## The Service Line

### **IS YOUR 75A-4 SMOKING MORE AND ENJOYING IT LESS ?**

**Figure 1. Schematic of AVC detector section showing cathode bias voltage divider R86 & R87.**

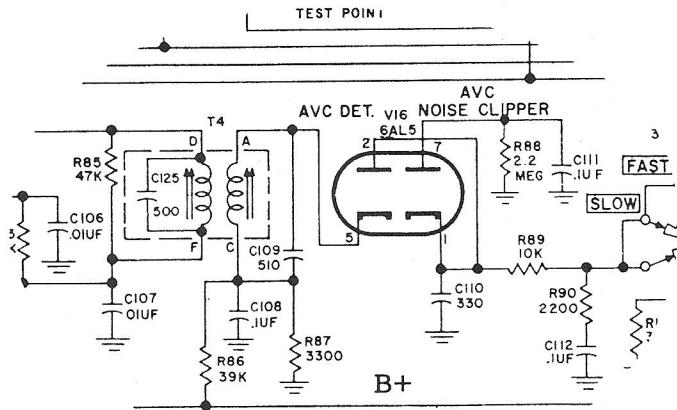
The culprit is a "smoking" R86, the 39K ohm 1/2 watt resistor used with R87 as a voltage divider from the B+ line to ground to develop the cathode bias level of 13-14 volts for the 6AL5 AVC rectifier V16. This positive bias of 13-14 volts on the cathode provides noise immunity for the AVC IF/detector chain and is very critical in providing stable and proper AVC and S-meter operation.

Referring to Figure 1, and using a conservative normal B+ level of 155V for the receiver running on a 110V line ("operate" position), the dissipation in R86, the 39K resistor, is calculated to be:

$$(155-14)^2 / 39 \times 10^3$$

or almost exactly 1/2 watt.

With 5% high line and R86 at -5% low tolerance, R86 dissipates over 1/2 watt.

Since the 50's when the venerable 75A-4 was designed, the nominal line voltage has changed from 110V to 120 or 125V, and on long lines or with high line tolerance, it can get even worse. With a line voltage of 120V, the B+ level will typically be 170 volts in the "operate" position, but note that it rises to 190 volts when the radio is in "standby" and there is less load on the power supply.

With the B+ voltage at 190 volts and R86 at its tolerance limit, R86 can be dissipating over .8 watt.

The symptoms of the resulting failure of R86, and sometimes R87 (if R86 goes low in value), are:

1. dramatically changed AVC threshold and action, and
2. inappropriate or unstable S-meter reading.

It is recommended that, regardless of condition, R86 be replaced with a 39K +/- 5%, 1 watt minimum, carbon resistor. A 2 watt is preferred as it is more conservative.

At the same time, check R87 to make sure it is within tolerance (3.3K +/- 5%). The 1/2 watt rating here is more than adequate. If R87 is out of spec, replace it also. The resulting voltage on the cathode of the 6AL5 (V16) should be approximately 14 volts with the correct value R86/R87 and the radio in the "operate" position.

The new R86 can be placed, as it was originally, under and behind C109 and allowing enough lead length to clear the alignment tool access on T4.
